PLANT NAME: **ACKNOWLEDGED** (2-P)
Oconee 1-2-3

Amdt. to ol/change to tech spec consisting of
request to revise the flux/flow trip setpoint
for unit 1 as well as incorporating a
surveillance testing requirement for the
internals vent valves.

Re: Oconee Nuclear Station
Docket Nos. 50-269, -270, and -287

Pursuant to 10CFR50, §50.90, Duke Power Company hereby requests a change in the Oconee Nuclear Station Technical Specifications. The proposed change consists of revising the flux/flow trip setpoint for Oconee Unit 1 as well as incorporating a surveillance testing requirement for the internals vent valves.

FIGURE 2.1-2A

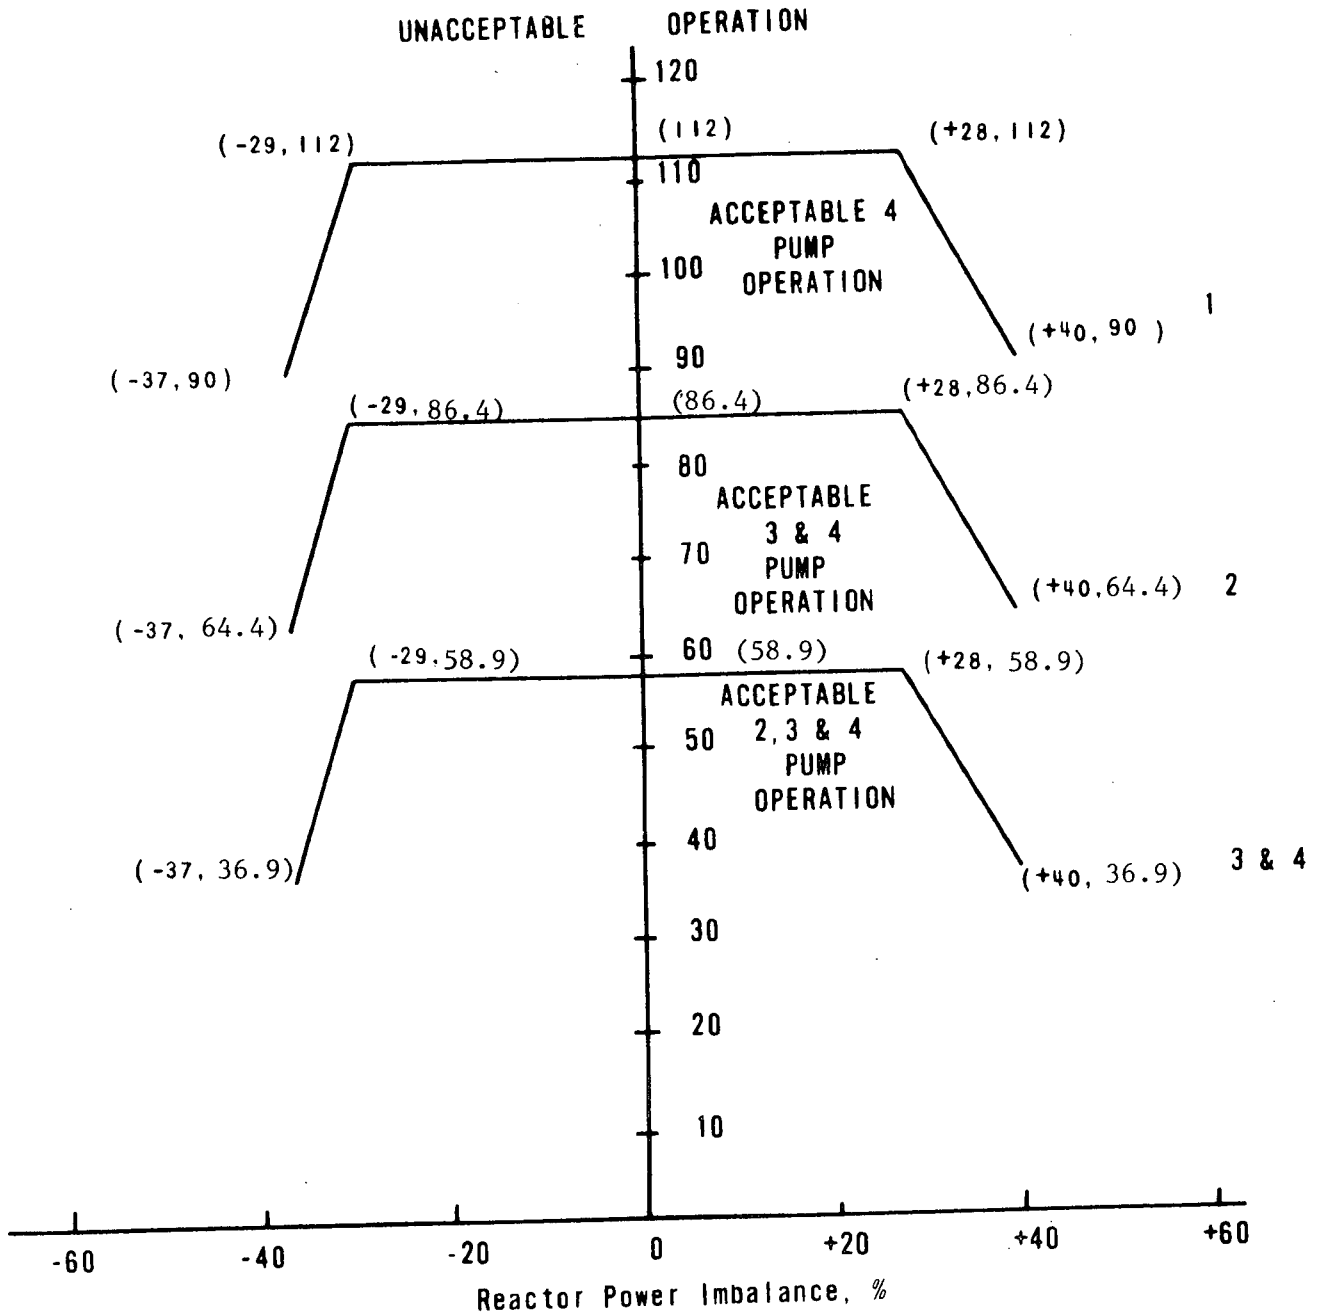
The specified flow rates for Curves 1, 2, 3 and 4 of Figure 2.1-2A correspond to the expected minimum flow rates with four pumps, three pumps, one pump in each loop and two pumps in one loop, respectively.

The maximum thermal power for three-pump operation is 86.4 percent due to a power level trip produced by the flux-flow ratio 74.7 percent flow \times 1.07 = 79.9 percent power plus the maximum calibration and instrument error. The maximum thermal power for other coolant pump conditions are produced in a similar manner.

FIGURE 2.3-2A

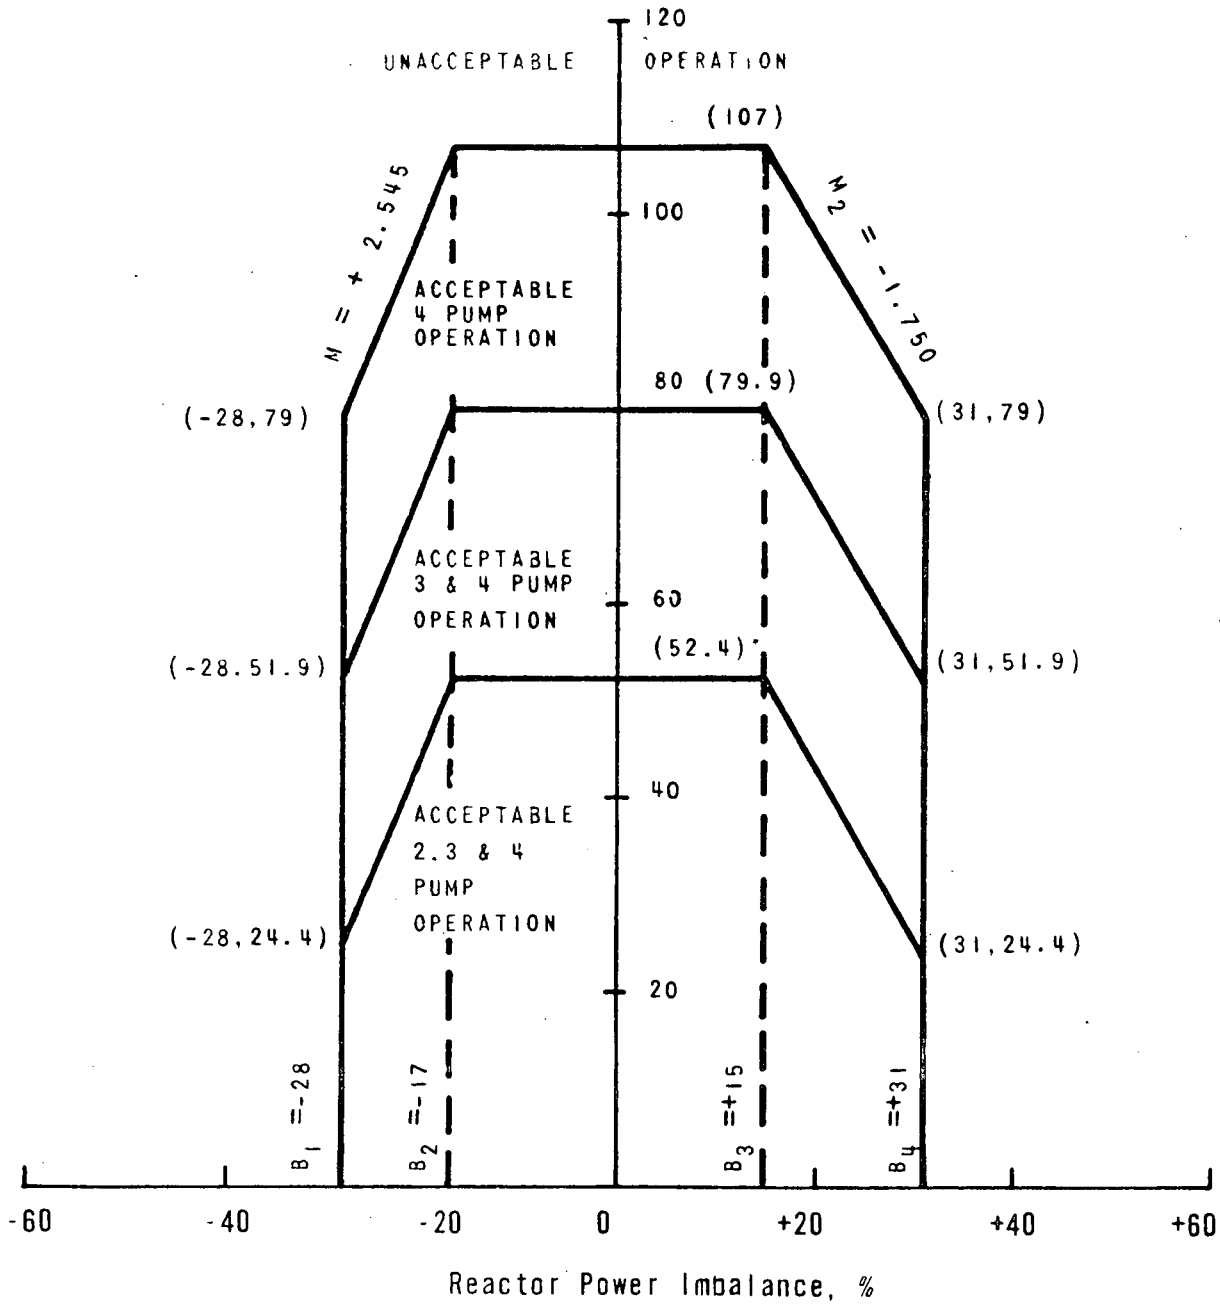
The power-imbalance boundaries are established in order to prevent reactor thermal limits from being exceeded. These thermal limits are either power peaking kw/ft limits or DNBR limits. The reactor power imbalance (power in the top half of core minus power in the bottom half of core) reduces the power level trip produced by the power-to-flow ratio such that the boundaries of Figure 2.3-2A - Unit 1 are produced. The power-to-flow ratio reduces the power

level trip and associated reactor power/reactor power-imbalance boundaries by 1.07% for a 1% flow reduction.

FIGURE 2.1-2A

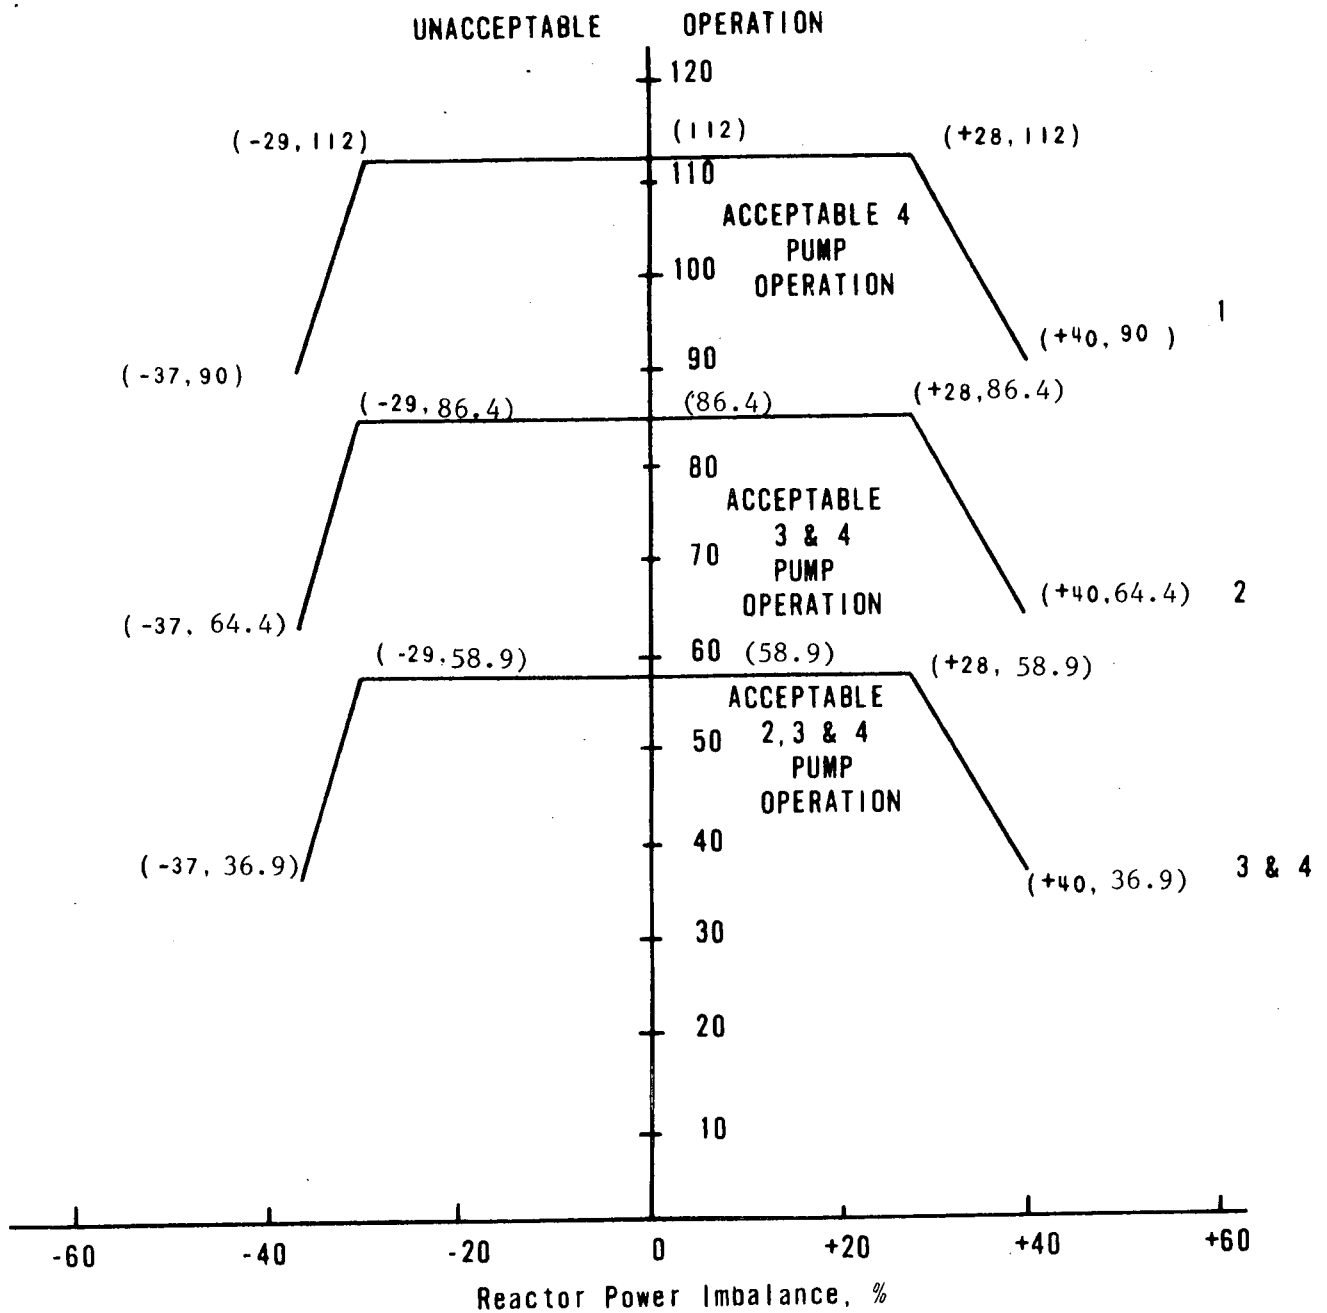
The specified flow rates for Curves 1, 2, 3 and 4 of Figure 2.1-2A correspond to the expected minimum flow rates with four pumps, three pumps, one pump in each loop and two pumps in one loop, respectively.

The maximum thermal power for three-pump operation is 86.4 percent due to a power level trip produced by the flux-flow ratio 74.7 percent flow \times 1.07 = 79.9 percent power plus the maximum calibration and instrument error. The maximum thermal power for other coolant pump conditions are produced in a similar manner.
